Applicant: Lectrosonics, Inc.
581 Laser Road
Rio Rancho, NM 87124

Re: Response to Correspondence reference number 31737

Equipment: FCC ID: DBZSML, 731-confirmation number EA540062

Photograph showing separation distance from the back of equipment to the antenna.

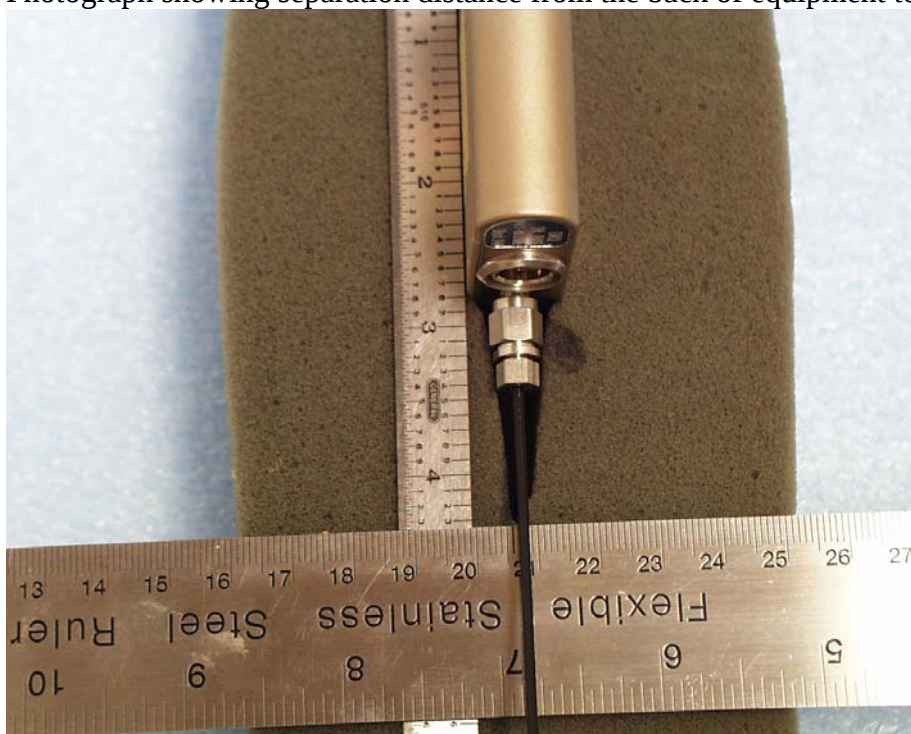
To support FCC RF exposure compliance determination, please submit photos and/or sketches for product with antenna installed showing spacings between the plane of the back of the belt-clip to: a) the back of the device, b) the closest point(s) of installed-antenna(s) FCC will then review all filing info to determine whether other info may need to be requested to support compliance with RF exposure requirements as applicable for all transmitters regulated by FCC. It may help to expedite this review if applicant has available and wishes to voluntarily submit SAR test results for this specific product

Below please find relevant photographs per your request demonstrating spacing between the back of the device and antenna, and the back of the clip and antenna.
